Re: Re: Site Address: Ward Court, 65 Sea Front, Hayling Island

Proposed Development Form 5 no. Flats at roof level and provide new cladding and render finish to existing building

Your Ref: APP/19/00722

H.M. LAND REGISTRY		TITLE NUMBER	
		HP58523	
ORDNANCE SURVEY PLAN REFERENCE	SZ 7198	SECTION A	Scale 1:1250 Enlarged from 1:2500
COUNTY	HAMPSHIRE	DISTRICT	HAVANT
			© Crown copyright 1976

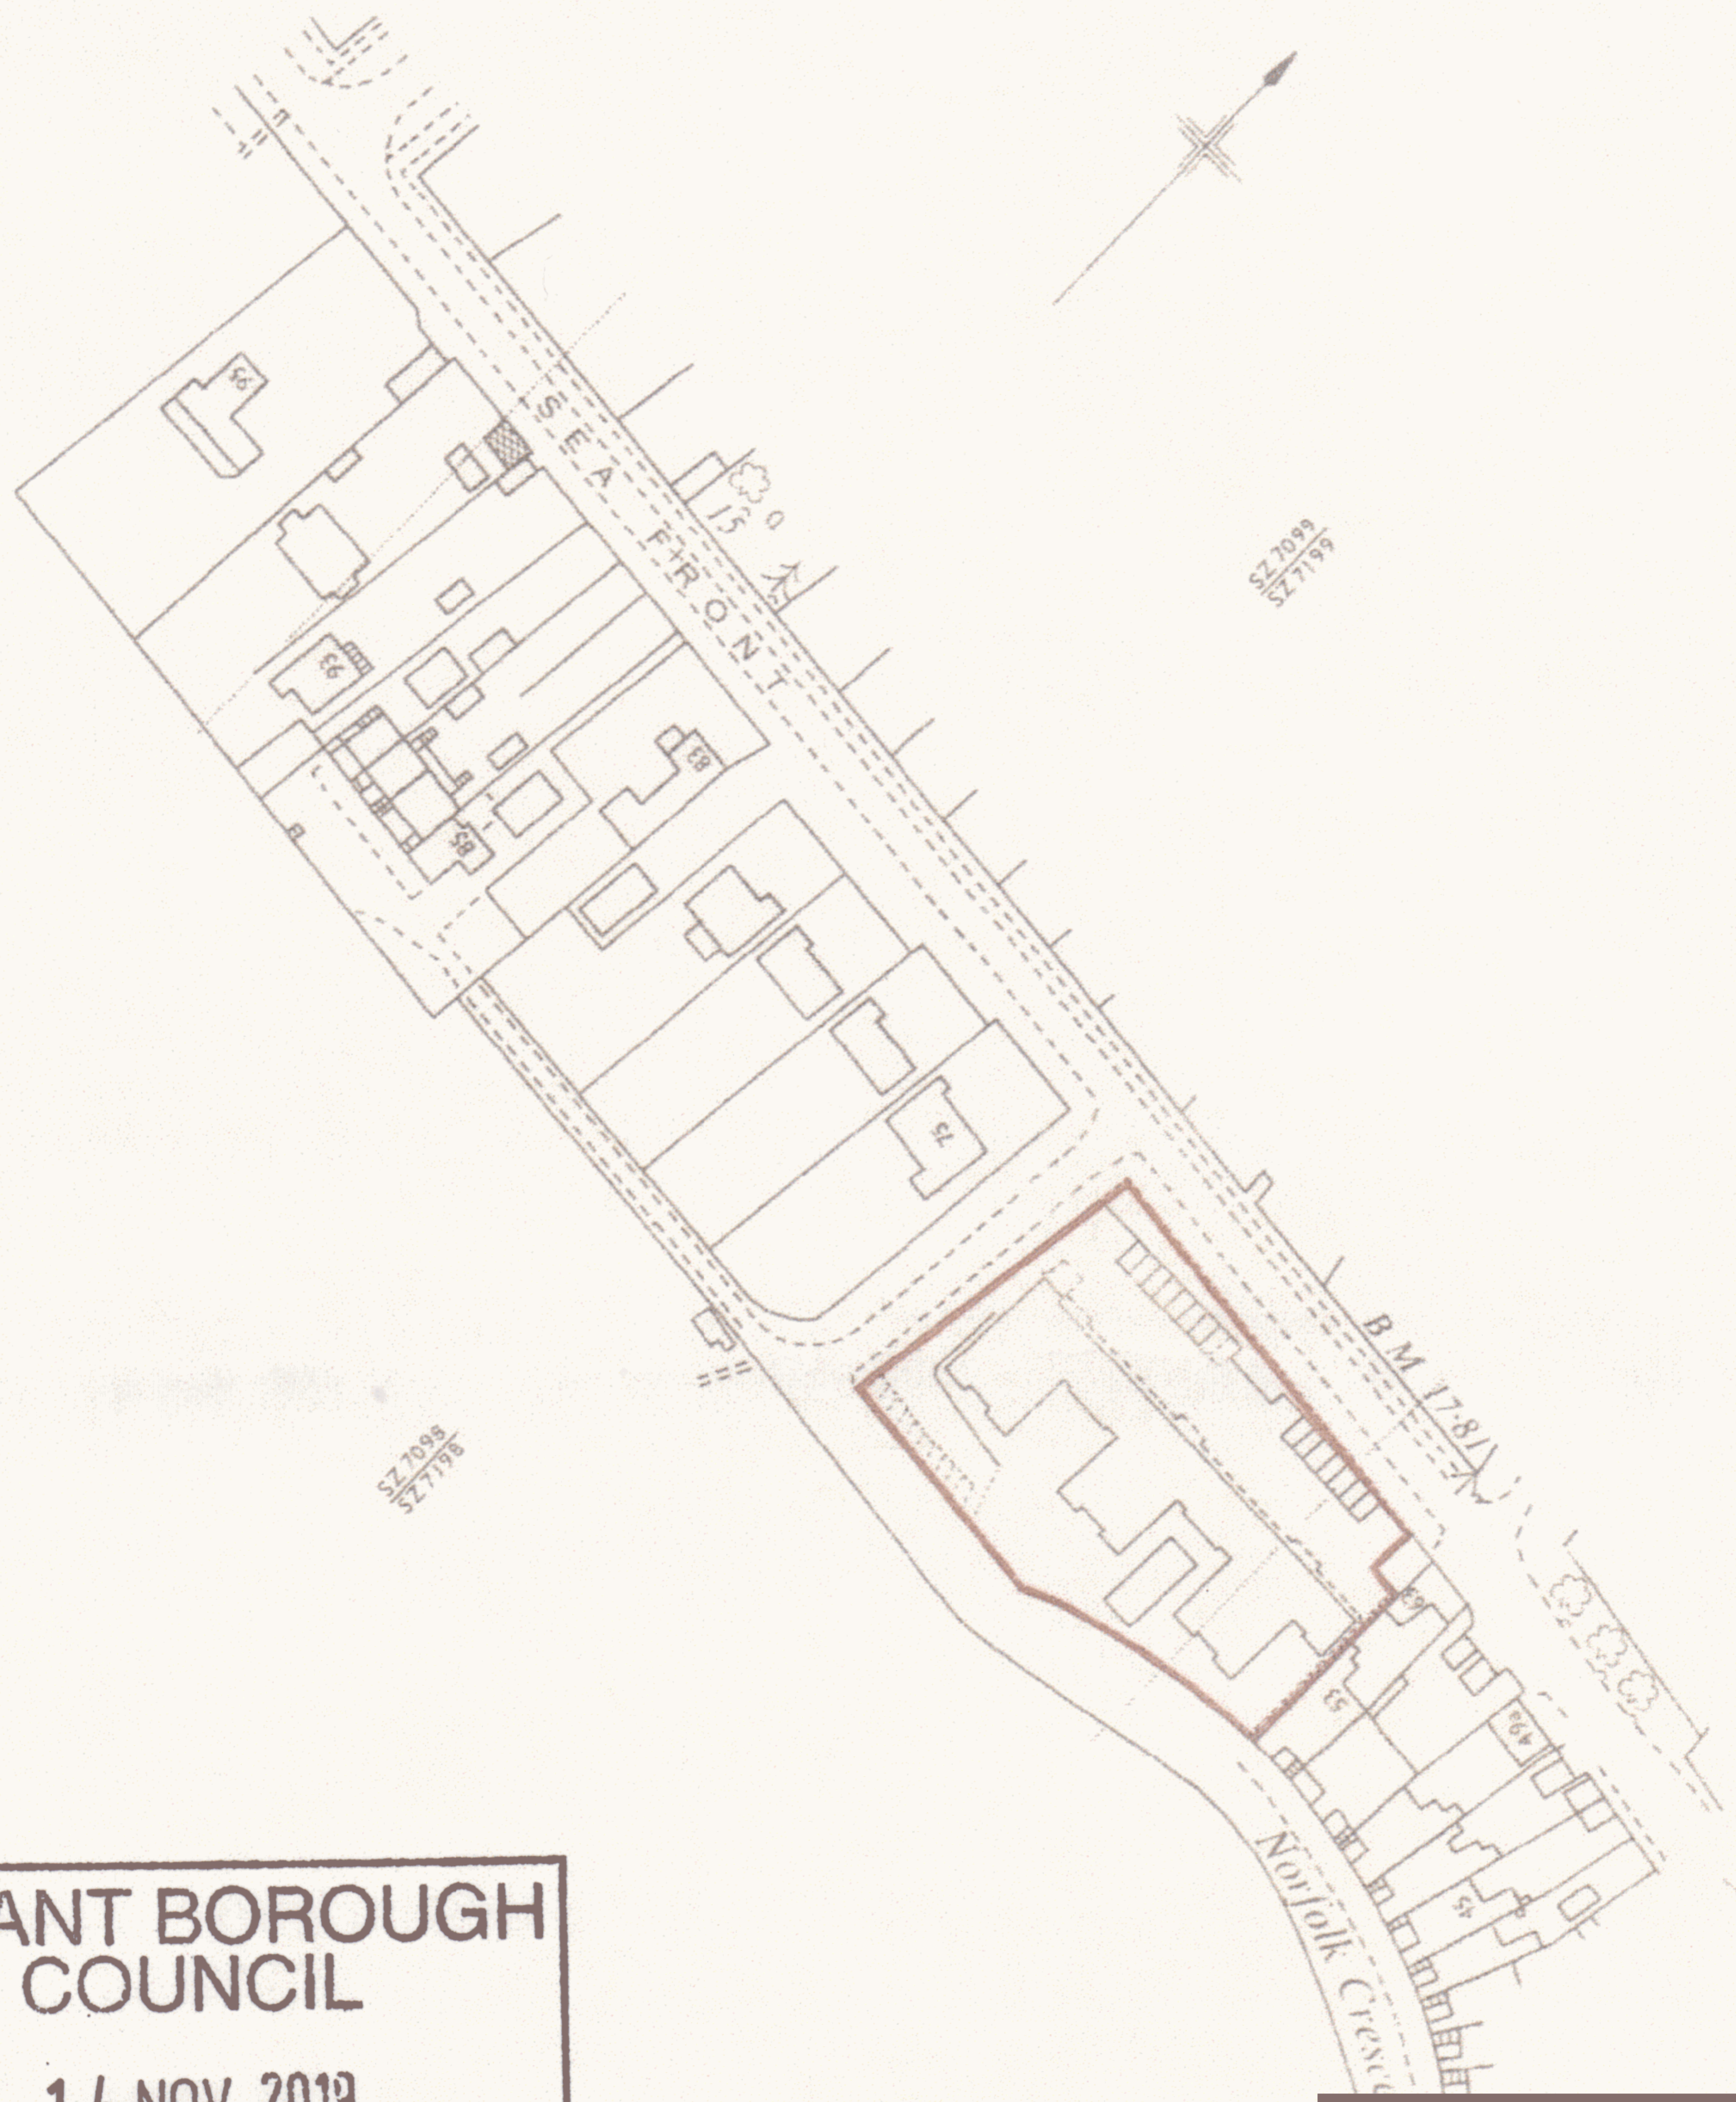
With regard to the remaining spaces outside the boundary wall I enclose the Land Registry file plan of the block from which it will be seen that the 5 spaces to the east of the entrance are not owned by the block. Part of this area is actually highway. Ownership of some of the 11 (not 10) spaces to the west of the entrance is also questionable because the boundary cuts diagonally across them. The applicants have placed signs on the wall all the way around the northern and western walls of the block threatening penalties to persons parking without a permit and has issued "permits" to residents to park in these areas. The applicants refuse to issue more than 2 permits per flat and employ a parking ticket company to issue tickets to residents or others whose cars are parked without a permit, even though with regard to the spaces to the east of the entrance, and the unadopted road on the west side of the block they have no right to do so.
